Proposed updates to TDECQ calculations for improved robustness and repeatability

802.3bs SMF Ad-hoc December 13 2016

Comparing TDECQ measurement stability for T and T/2 equalizer tap spacing

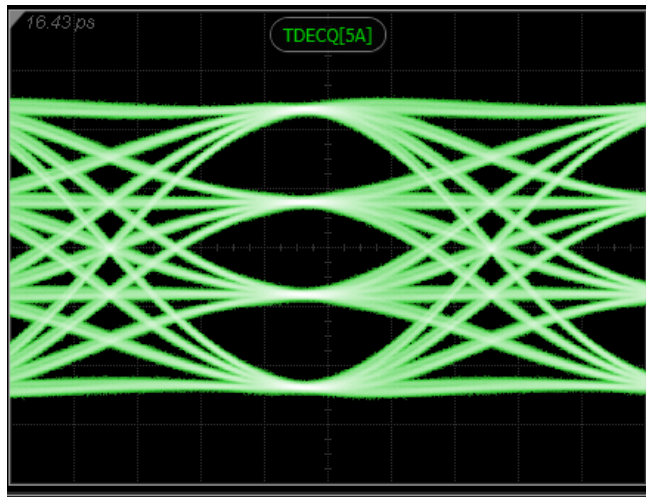
- At the last SMF ad hoc call, T/2 tap spacing was identified as a possible source of TDECQ measurement repeatability problems
 - We need to avoid possible implementations that provide lower TDECQ penalties for the wrong reasons
- As an example, instrumentation noise (known as the σ_s term in the TDECQ mathematics) was used to exhibit how the noise gain variability of a T/2 spaced equalizer can improperly bias the measurement result
- Unfortunately, the ensuing discussion then focused on oscilloscope noise and skewed responses away from the original measurement repeatability problem
- The overall TDECQ measurement problem is manifest for other scenarios that are completely independent of instrumentation noise

Example of MMSE with T/2

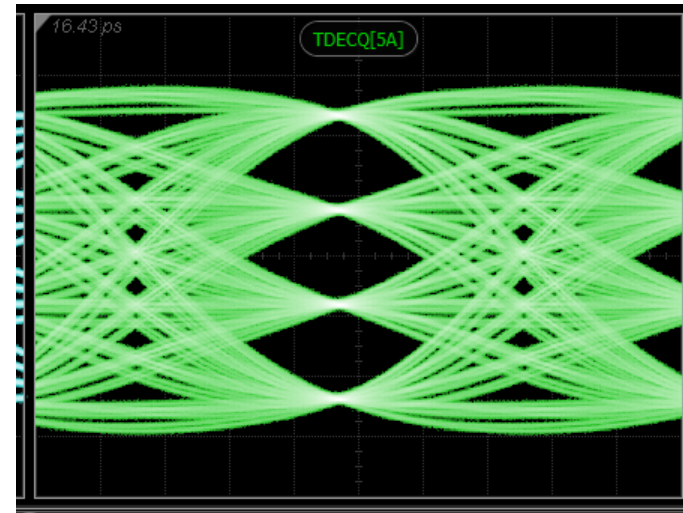
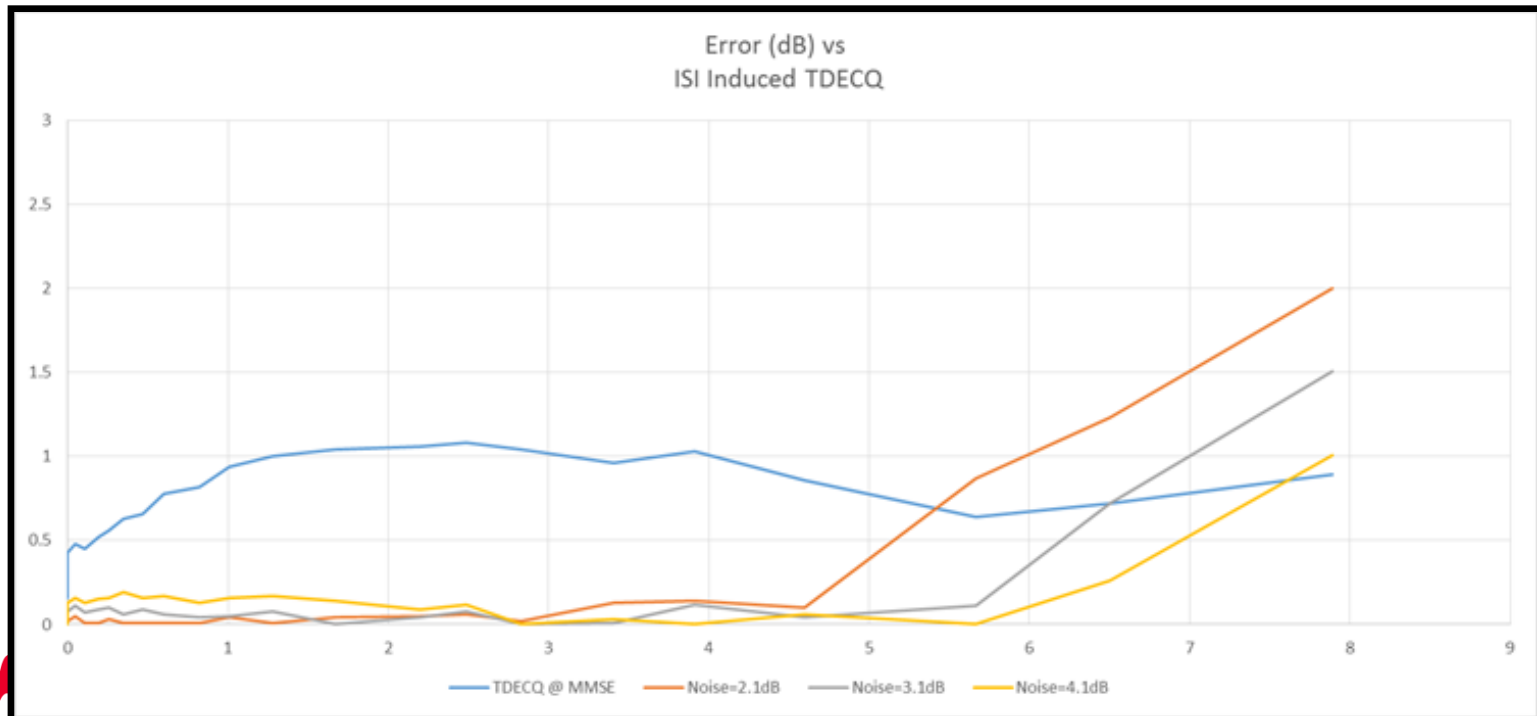
The equalizer on the left was optimized with straight MMSE. It has a larger eye opening but also has worse TDECQ because of an increased noise gain (smaller C_{eq})

Measurement		Current
Eye 1/2 Width (1.0E-6)	F1	21.19 ps
Eye 1/2 Height (1.0E-6)	F1	133.2 μ W
TDECQ	F1	1.47 dB

Measurement		Current
Eye 1/2 Width (1.0E-6)	F1	15.85 ps
Eye 1/2 Height (1.0E-6)	F1	132.2 μ W
TDECQ	F1	1.27 dB
